mercruiser
STERN DRIVES & INBOARDS

service bulletin

No. 92-18

A. WEBER CARBURETOR ADJUSTABLE ACCELERATOR PUMP

70472

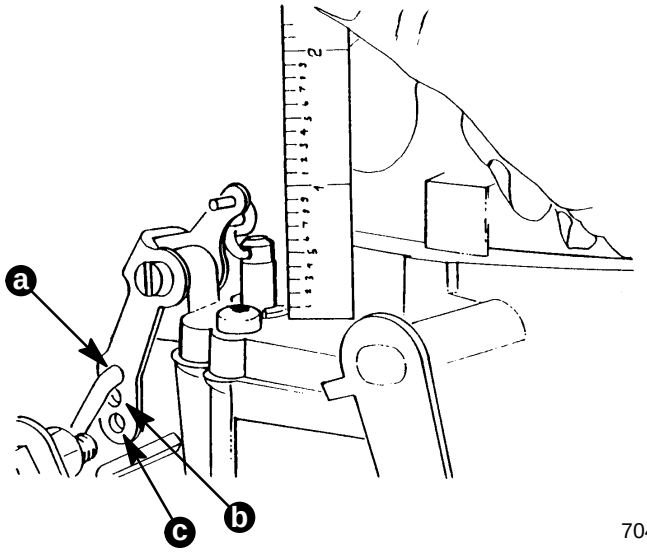
The accelerator pump lever has three holes in it. The closest hole to the lever's pivot point is the richest, the second hole is leaner and the hole farthest away is the leanest. All production carbs have the pump rod installed in the closest (richest) hole. If you are having a "rich" bog on acceleration, move the rod to the second or third hole. Weber put the three holes in the lever so the amount of fuel delivered by the accelerator pump could be changed.
